From: Barna, Roberta (EXT) [REDACTED] >
Sent: 12 August 2026 12:22
To: Chris Johnston
Cc: Emily Summers; Planning (SMDC); DCsupport; Andrew Dowell
Subject: New Buildings Farm Solar Farm (SMDC - SMD/2025/0388 and ESBC - P/2026/00149) - LLFA Response (Rev 2)
Attachments: Flood Risk Assessment V3 Part 2_Received 13.03.2026.pdf

Staffordshire County Council Flood Risk Management position

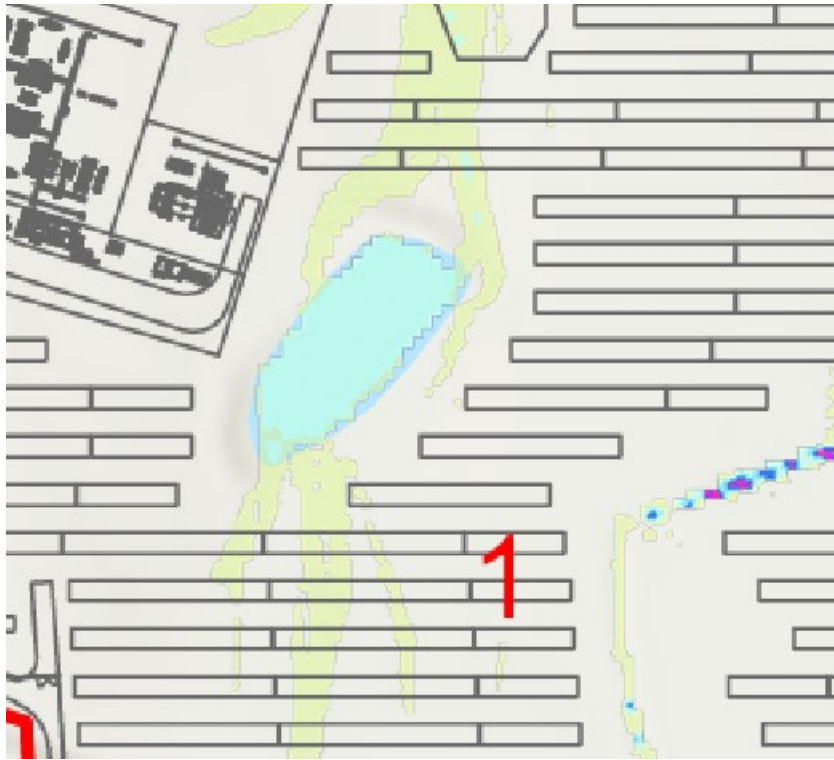
Section 3.10.1 states that the inputs from the formal drainage of the substation drainage strategy and the addition of the substation itself could not be included in the modelling as it couldn't accurately be represented in flood modeller.

If you do not have an alternative method to represent this in the 2D domain, as per the methodology outlined for transformers can the substation area just be raised to simulate the diversion of surface water around it as per the methodology with the transformers.

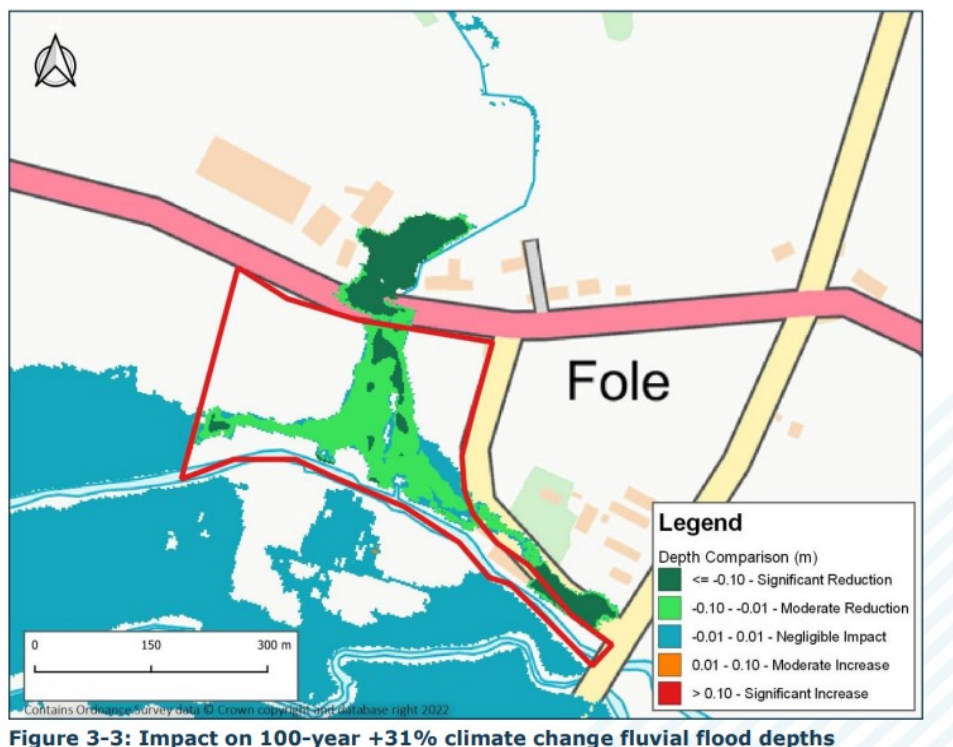
- Please clarify the representation of the existing water levels within existing ponds within the Lidar, it might be that you would need to add a water level as a z-shape so they're not artificially adding storage to the model that isn't there e.g. pond in screenshot below (but should be considered for all existing ponds within the 2D domain).
